REQUEST FOR INFORMATION	DATE: June 22, 2017	NO.: RFI-570
--------------------------------	----------------------------	---------------------

Project Name: 15051-Webster University Interdisciplinary Science Building	Project No.: 15051
---	--------------------

Subject: Lighting Layout at Pavers

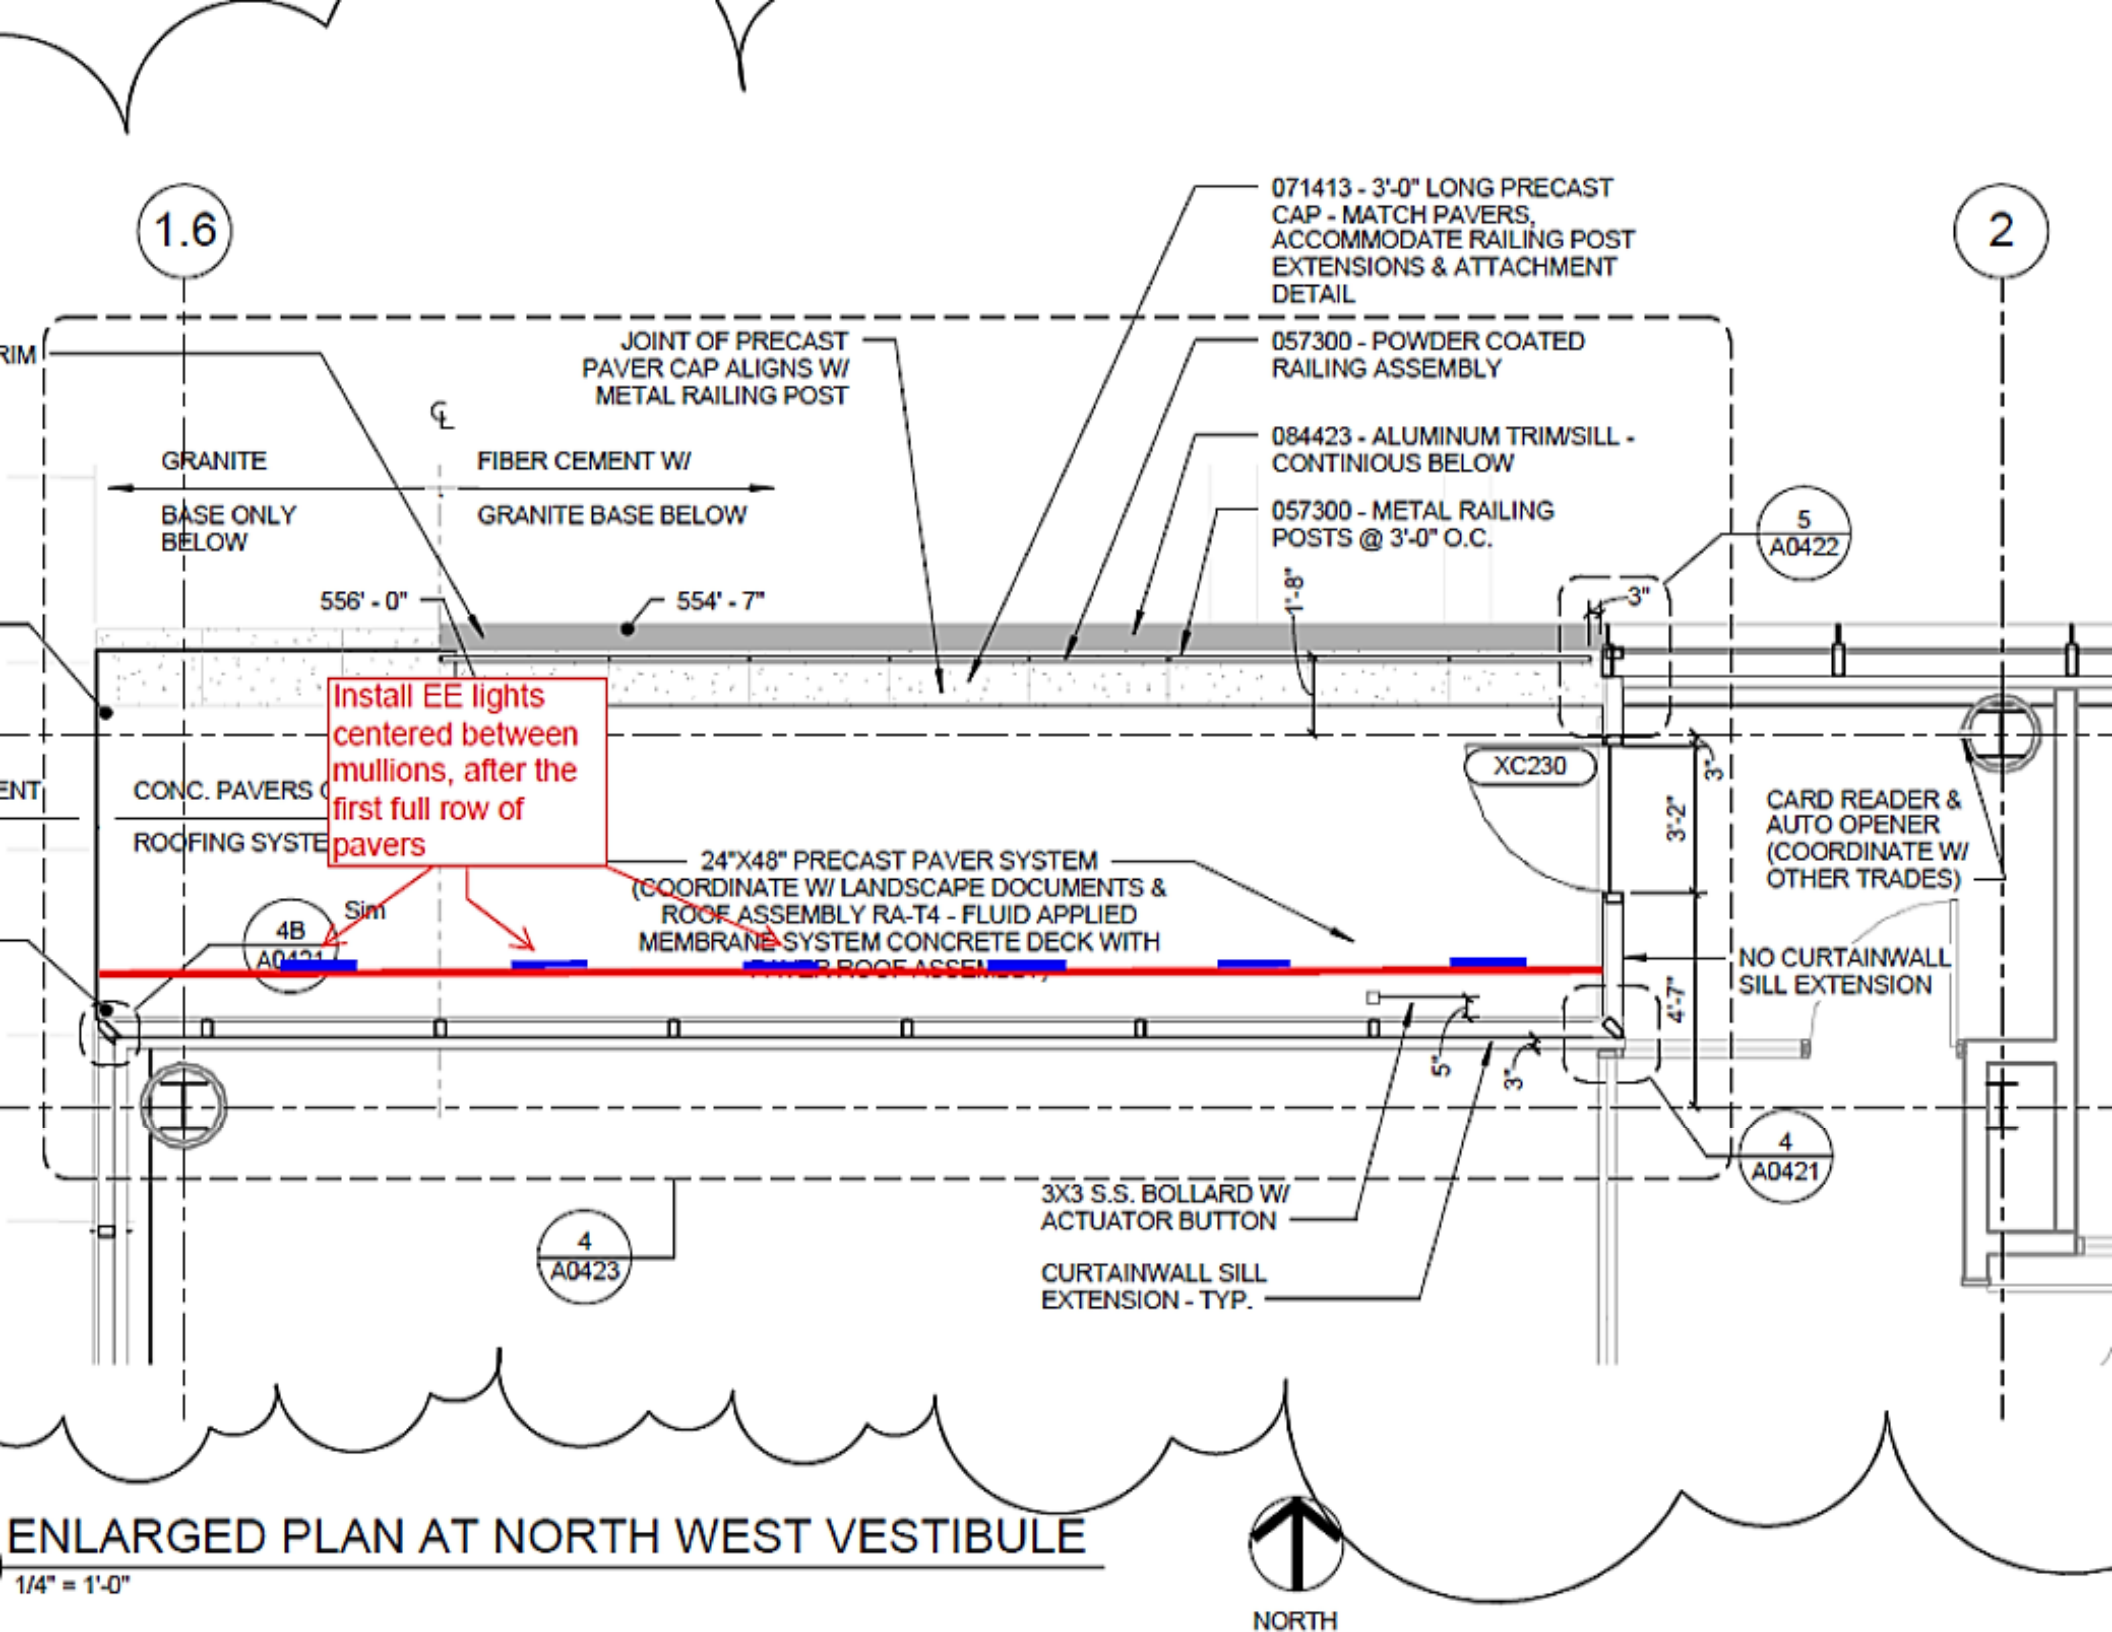
E0001calls for lights in the pavers but does not provide a layout. See attached sketches.

Suggestion: Paric proposes to install the EE lights shown after the first row of full pavers centered in between the mullions to reduce paver cuts. Please advise if this is acceptable.

The proposed location is acceptable to WTA.

ENLARGED PLAN AT NORTH WEST VESTIBULE

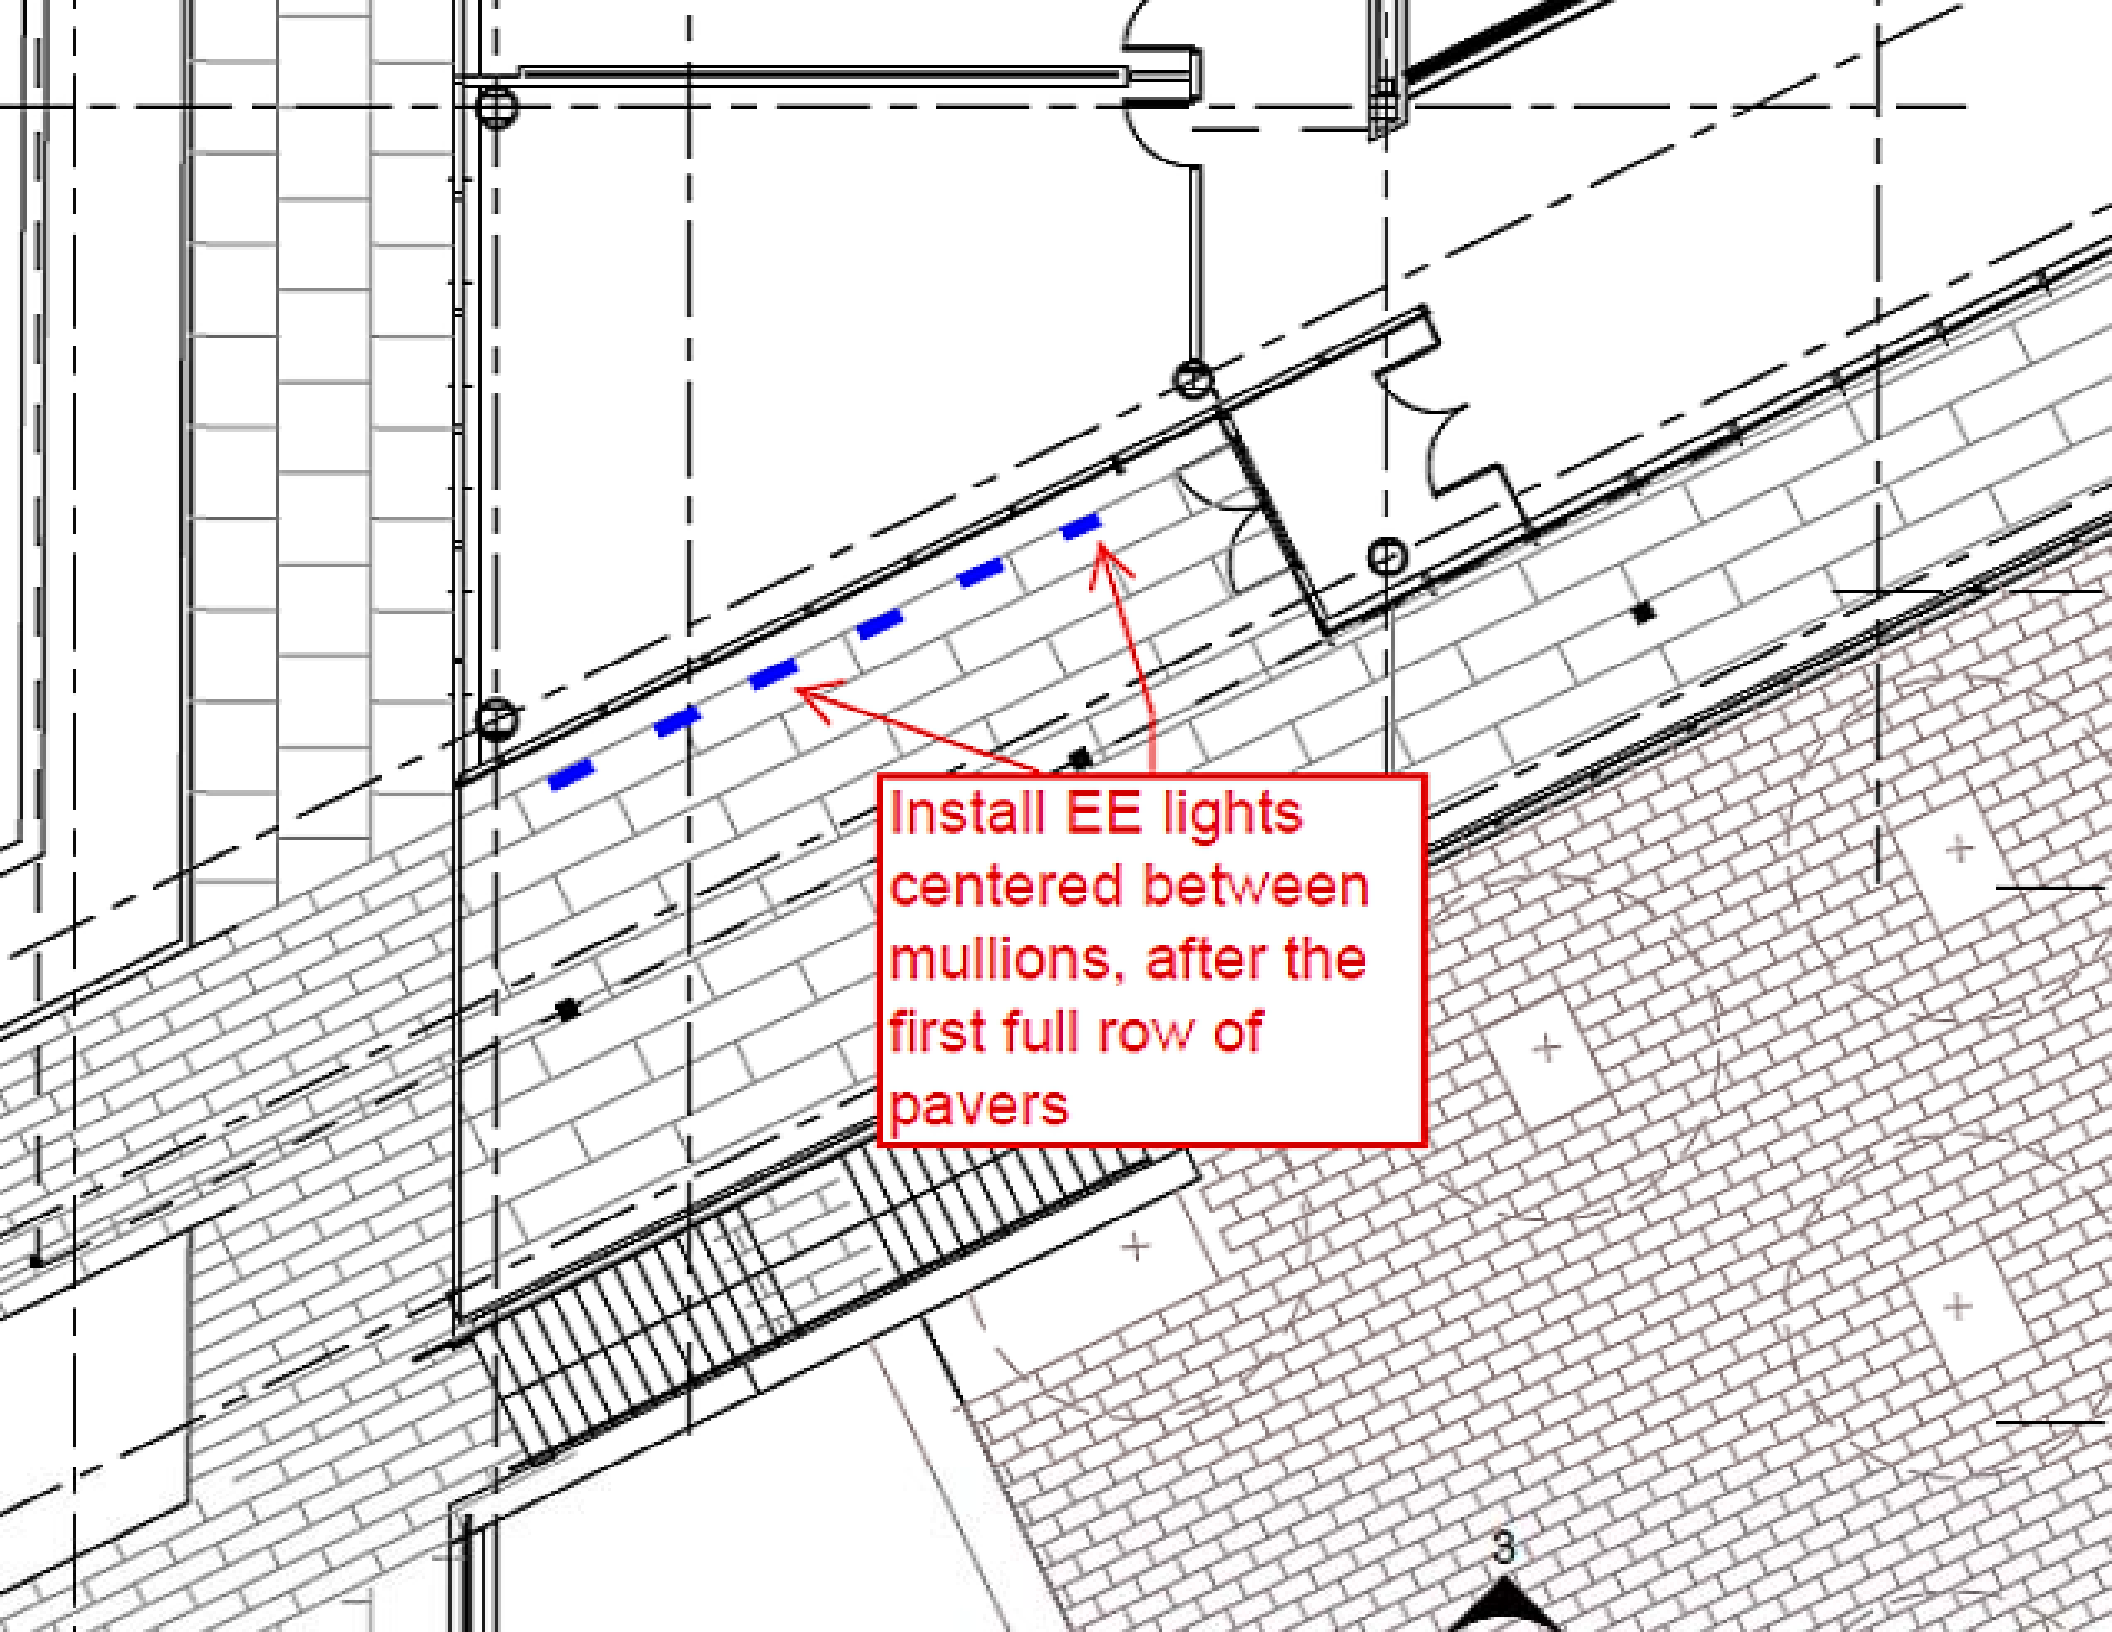
Install EE lights
centered between
mullions, after the
first full row of
pavers
